Sladden Engineering

January 20, 2022

Project: Proposed Industrial/Warehouse Buildings
APN 314-091-005
Seaton Avenue
Perris Area
Riverside County, California

Ref: Geotechnical Investigation report prepared by Sladden Engineering dated December 23, 2020; Project No. 644-20039, Report No. 20-12-093

TRK: OVERALL SITE PLAN

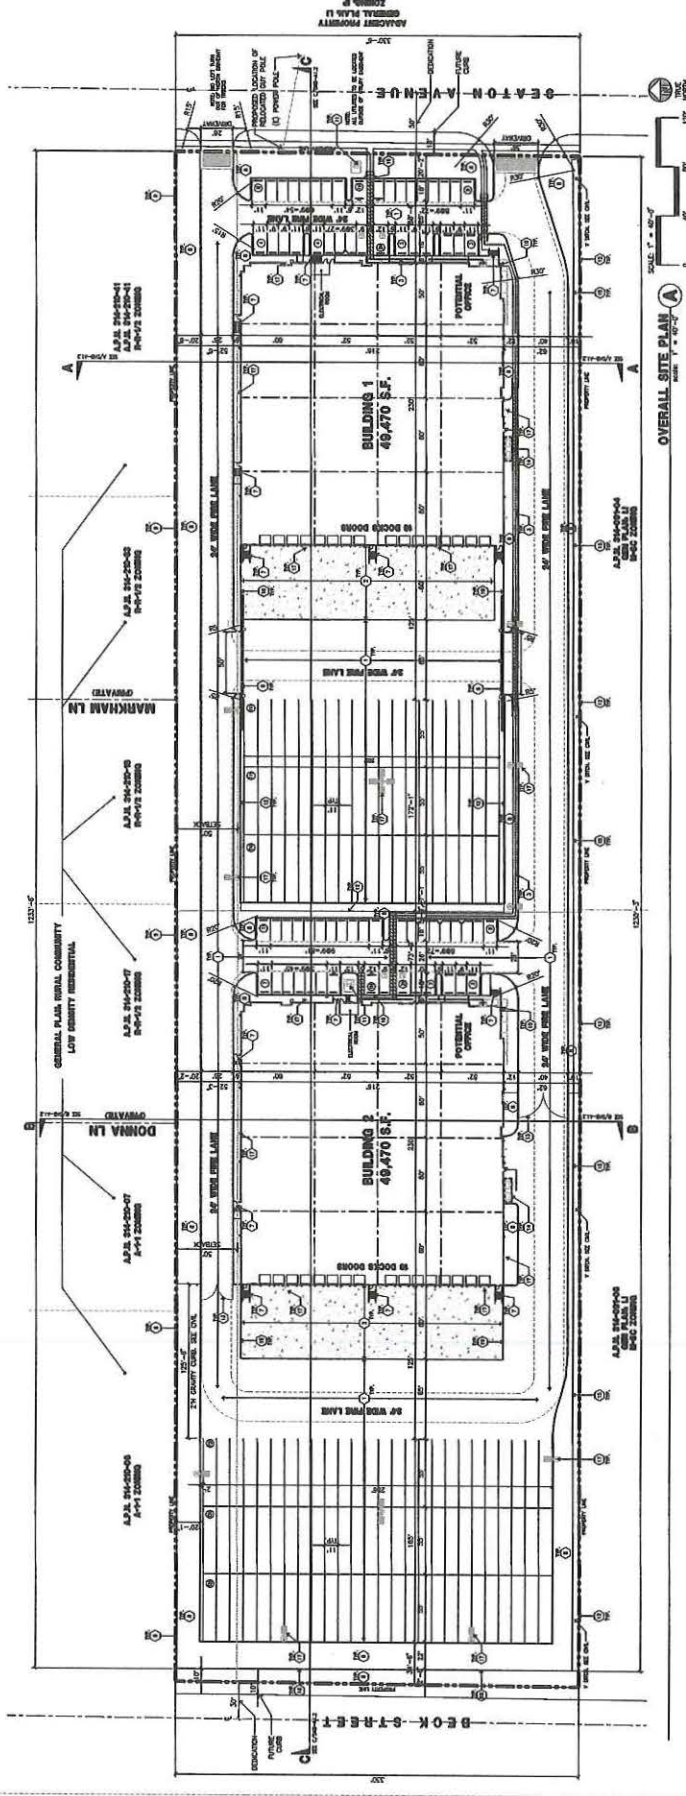
In accordance with your request, we have reviewed the most recent development plans for the subject property (APN 314-091-005) located between Seaton Avenue and Beck Street just north of Perry Street in the Perris area of Riverside County, California. The current plans (attached) indicate two industrial/warehouse buildings in lieu of the single industrial/warehouse building indicated on the initial plans. The proposed development, grading and building construction type remain consistent with the assumptions considered in the development of the recommendations provided within the above referenced report. It is our opinion that the recommendations provided within the referenced Geotechnical Investigation report remain applicable for use in the design and construction of the currently proposed project.
